RANCHO MIRAGE DOG PARK

CITY OF RANCHO MIRAGE
69825 HIGHWAY 111
RANCHO MIRAGE, CA 92270
C.P. 14-311

<p>IMPORTANT NOTICE CALL BEFORE YOU DIG SECTION 4216 OF THE GOVERNMENT CODE REQUIRES AN INDUSTRY IDENTIFICATION NUMBER BE ISSUED BEFORE A PERMIT TO EXCAVATE WILL BE ISSUED. FOR YOUR PRE-EXCAVATION ID NUMBER CALL UNDERGROUND SERVICE ALERT TOLL FREE 1-800-227-2600 TWO WORKING DAYS BEFORE YOU DIG</p>	<p>UNAUTHORIZED CHANGES & USES: THE ENGINEER PREPARING THESE PLANS WILL NOT BE RESPONSIBLE FOR, OR LIABLE FOR, UNAUTHORIZED CHANGES TO OR USES OF THESE PLANS. ALL CHANGES TO THE PLANS MUST BE IN WRITING AND MUST BE APPROVED BY THE PREPARER OF THESE PLANS.</p> <p>ENGINEER'S NOTE TO CONTRACTOR: CONSTRUCTION CONTRACTOR AGREES THAT IN ACCORDANCE WITH GENERALLY ACCEPTED CONSTRUCTION PRACTICES, CONSTRUCTION CONTRACTOR WILL BE REQUIRED TO ASSUME SOLE AND COMPLETE RESPONSIBILITY FOR JOB SITE CONDITIONS DURING THE COURSE OF CONSTRUCTION OF THE PROJECT, INCLUDING SAFETY OF ALL PERSONS AND PROPERTY, THAT THIS REQUIREMENT SHALL BE MADE TO APPLY CONTINUOUSLY AND NOT BE LIMITED TO NORMAL WORKING HOURS, AND CONSTRUCTION CONTRACTOR FURTHER AGREES TO DEFEND, INDEMNIFY AND HOLD DESIGN PROFESSIONAL HARMLESS

| 10 | PRECISE GRADING PLAN |

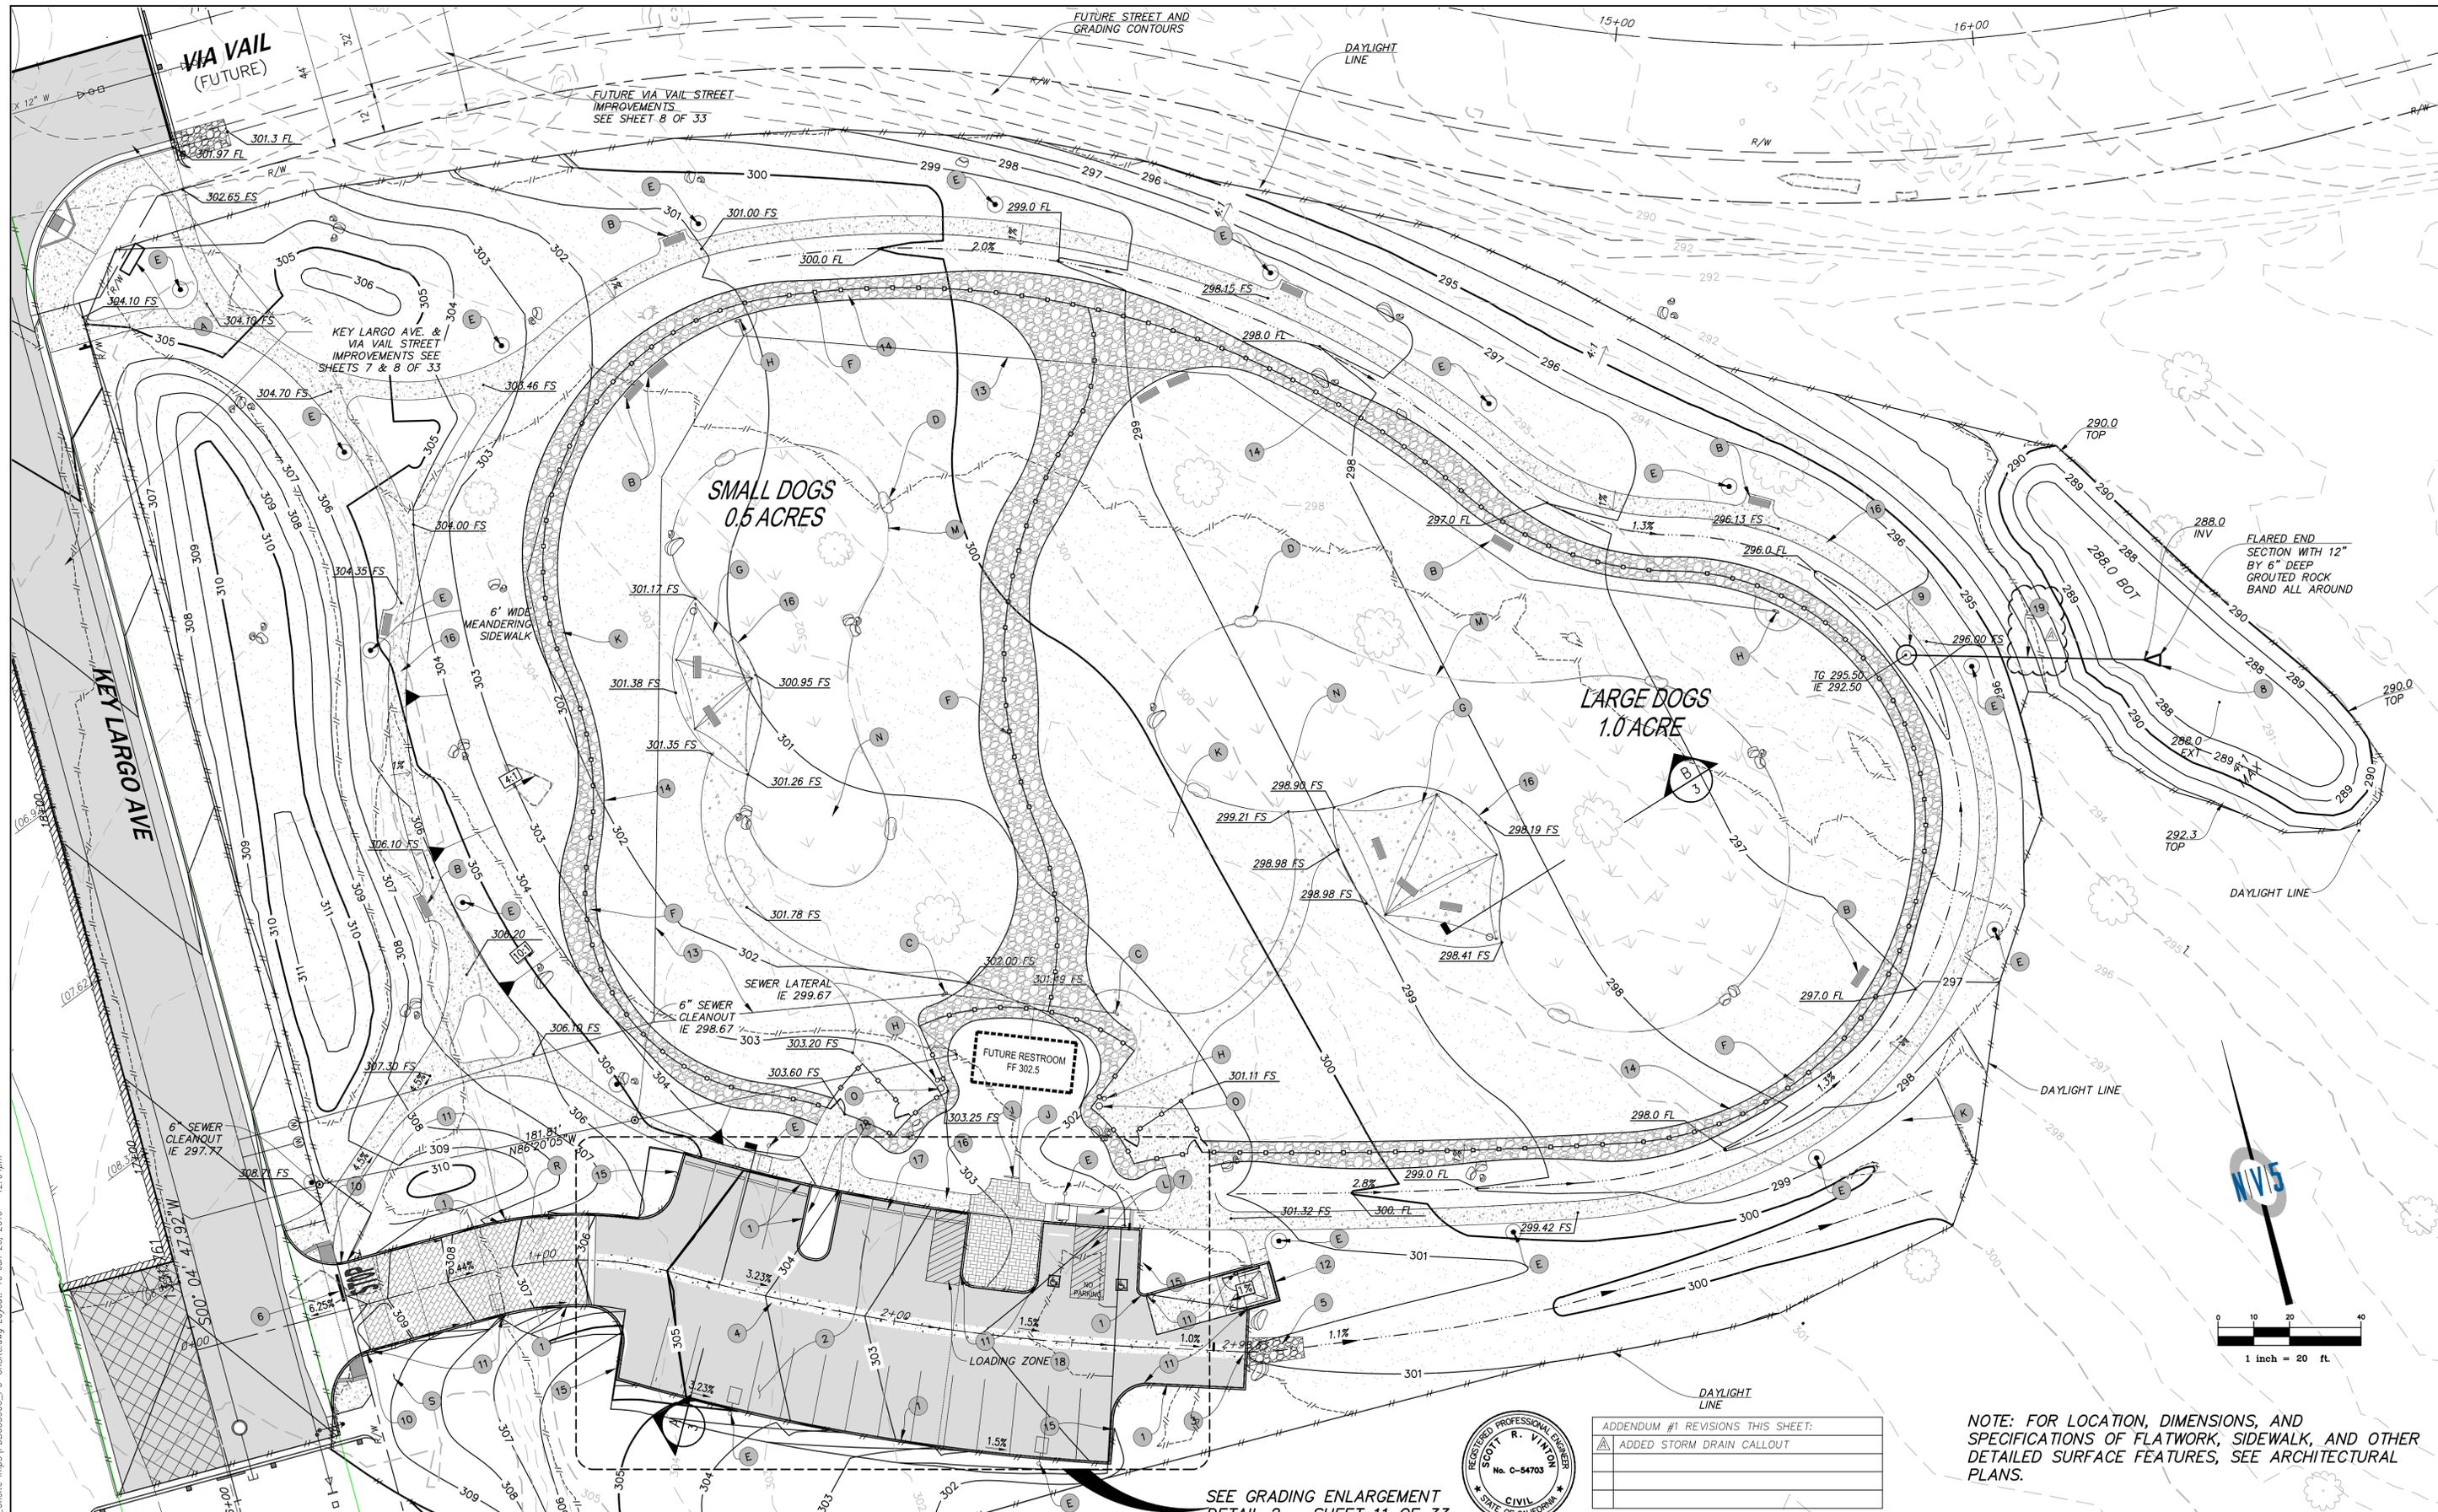
ADDENDUM #1 REVISIONS THIS SHEET:	
⚠	REVISED HATCHING PATTERNS IN LEGEND
⚠	ADDED 18" STORM DRAIN ITEM & QUANTITY

▲	ADDED STORM DRAIN CALLOUT

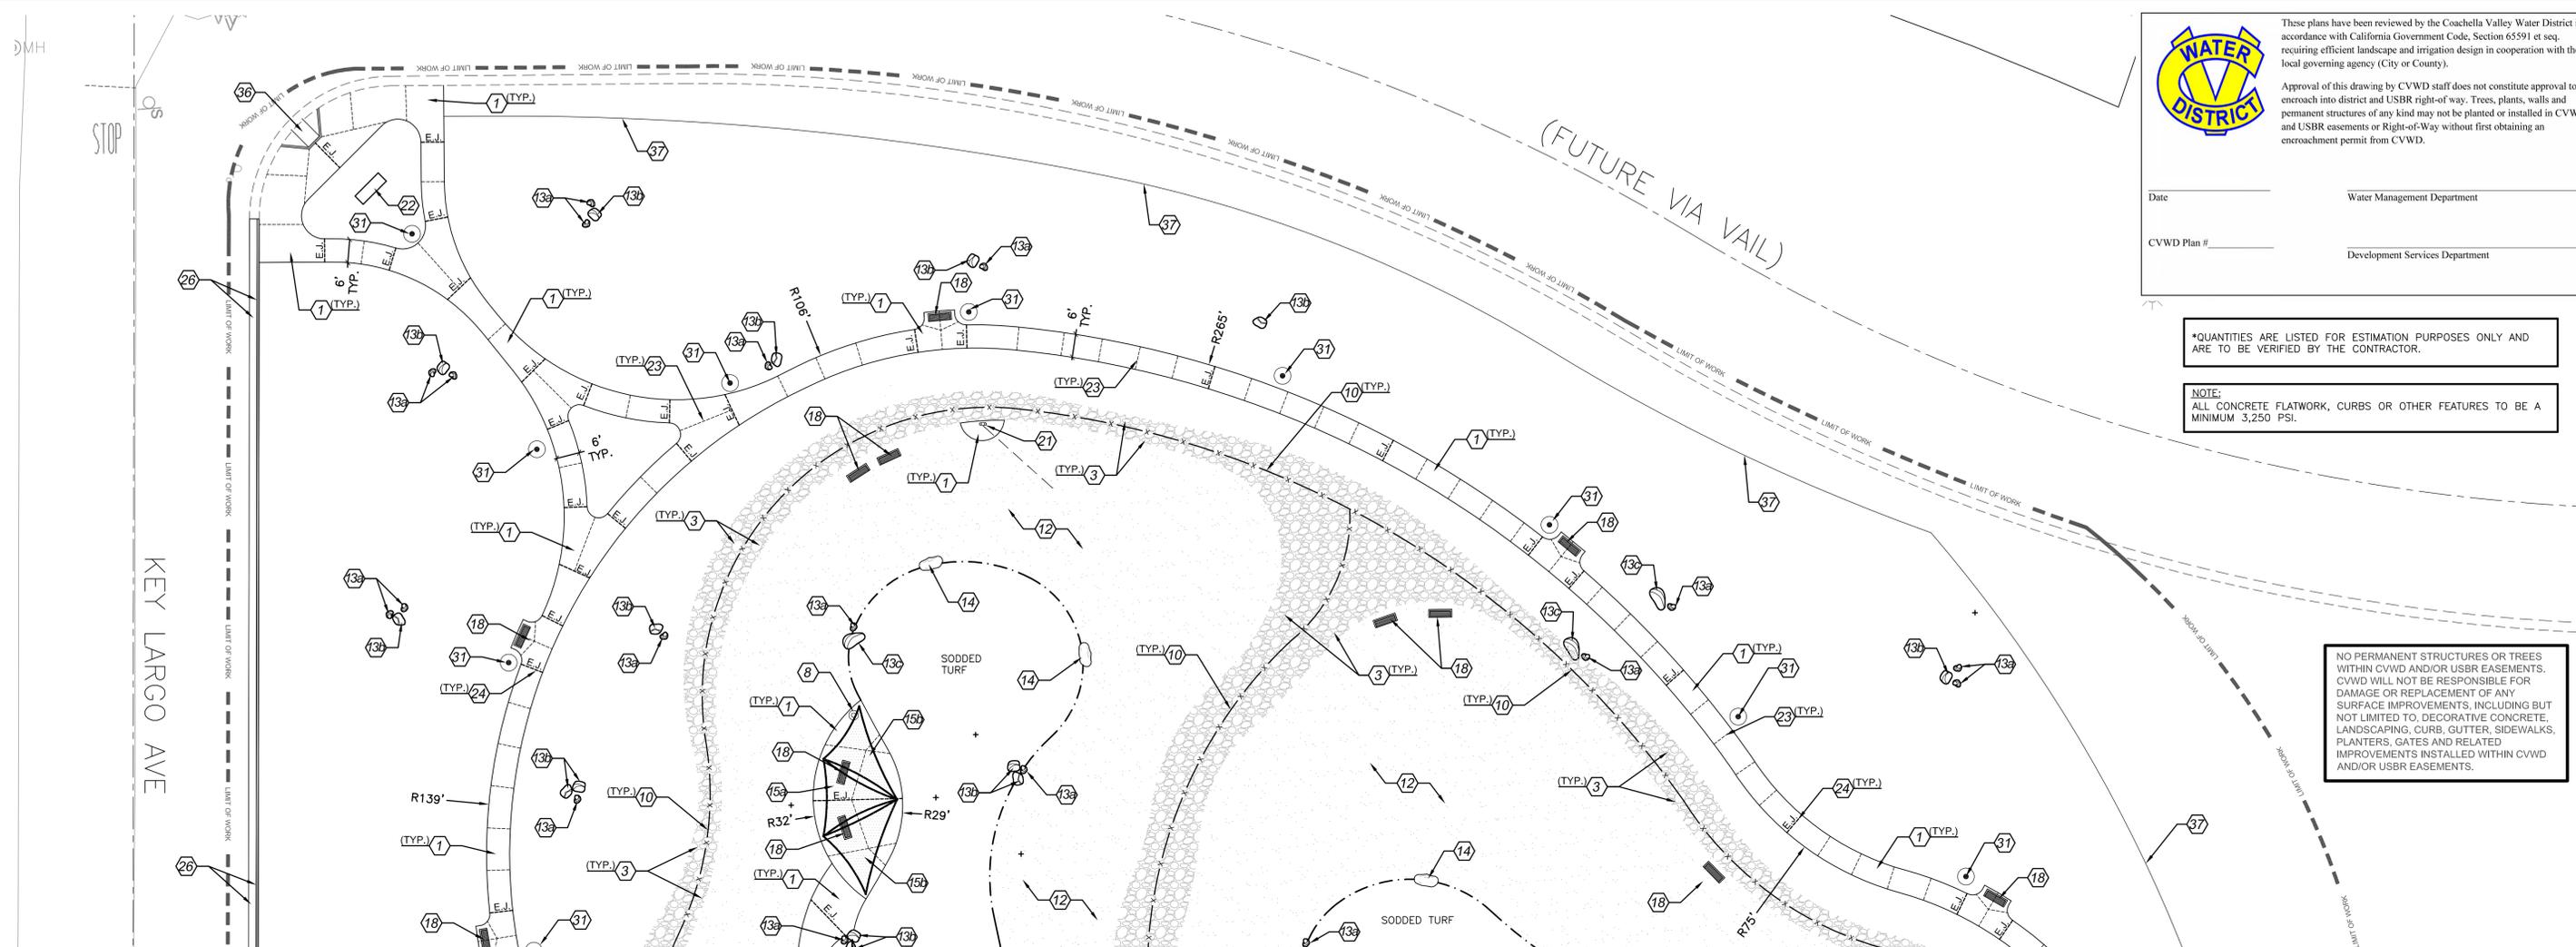
- ADDENDUM #1 REVISIONS THIS SHEET:
- 1 REVISD CONCRETE COLOR TO 'YOSEMITE BROWN'. AFFECTS ITEMS 1, 2, 9, 32, 34, 35, 36.
 - 2 REVISD CRUSHED ROCK COLOR 'MINER'S GOLD'. AFFECTS ITEM 3.
 - 3 REVISD FENCE/GATE TYPE TO 'MONTAGE PLUS PPP'. AFFECTS ITEMS 10 & 11.
 - 4 ADDED REDWOOD HEADER AT LIMITS OF DECOMPOSED GRANITE. AFFECTS ITEM 37.
 - 5 REVISD SHADE SAIL FABRIC TYPE & COLOR. AFFECTS ITEMS 15a, 15b, 15c.
 - 6 ADDED DETAIL FOR DRINKING FOUNTAINS. AFFECTS ITEMS 20 & 21.
